FACILITY: Three Mile Island Nuclear Station, Unit 1

SUBJECT: SUMMARY OF OCTOBER 20, 2009, MEETING WITH EXELON TO DISCUSS PROPOSED CONTROL ROD DRIVE CONTROL SYSTEM LICENSE AMENDMENT REQUEST (TAC NO. MD9762)

EXELON PRESENTATION TO NRC REGARDING REACTOR TRIP BREAKER MODIFICATION

Block Diagram of Undervoltage and Shunt Trip Devices in the Reactor Trip Breaker

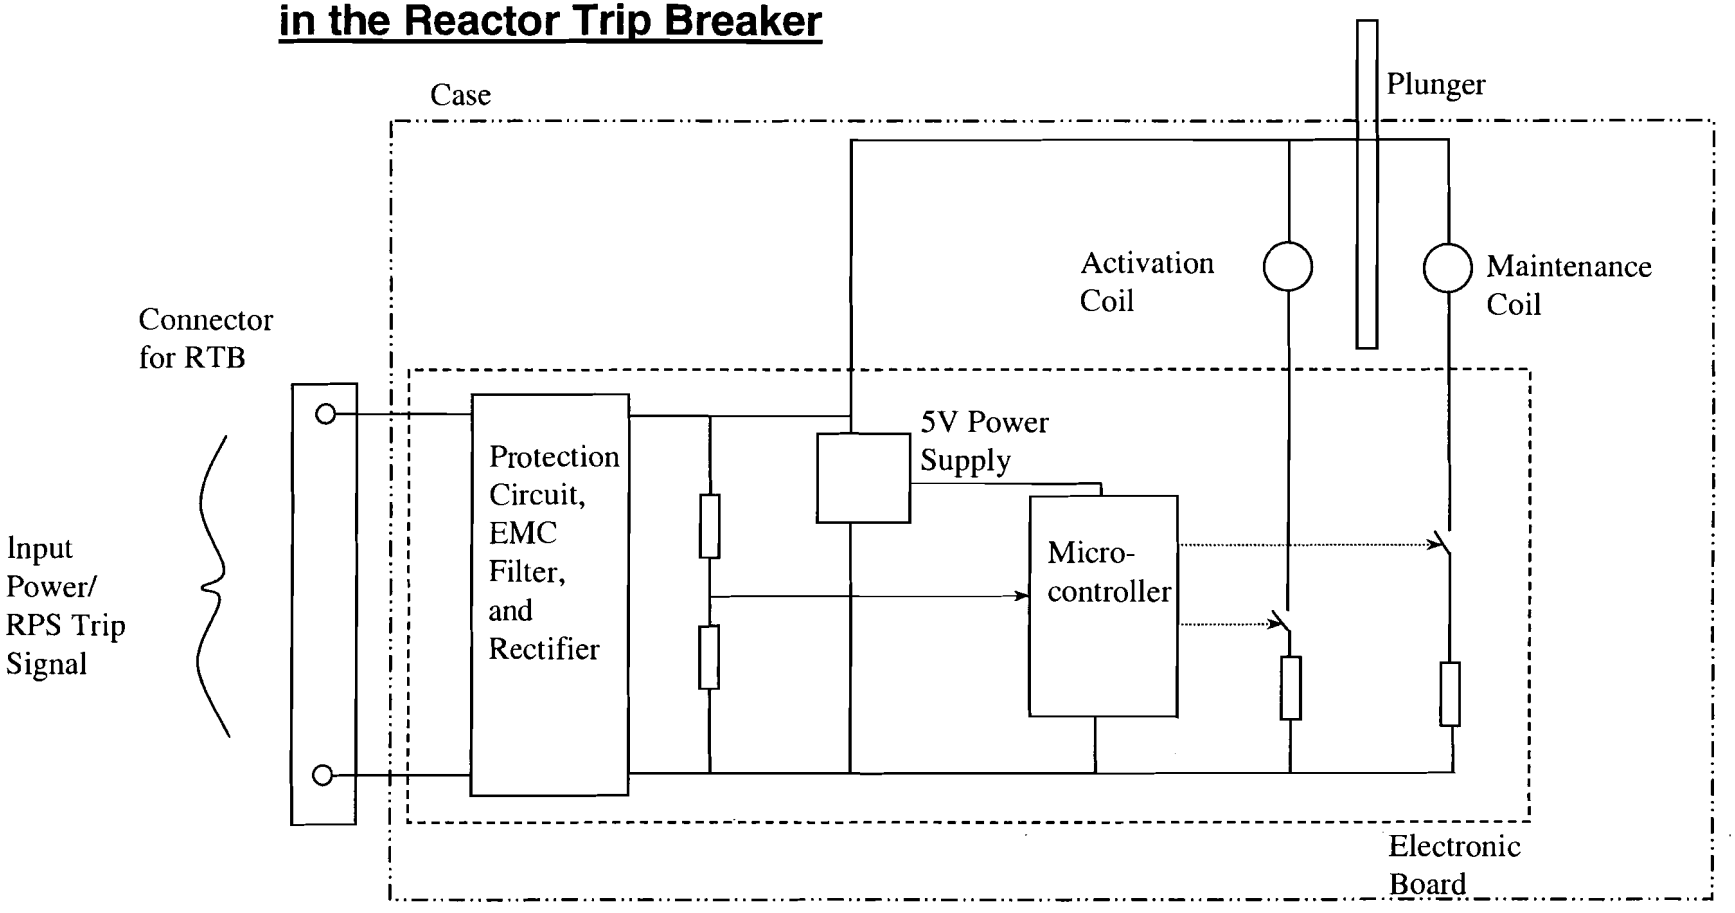
1. How complex is this microcontroller?
   - How many logical operations are going on?
   - What are these logical operations doing?

A b*lock diagram of the microcontroller is included as page 9 of presentation. The microcontroller is simple and consists of 8 modules. Details are presented in section 2.2.2.17.2 of the V&V report. The V&V report identifies the operation of the code.*
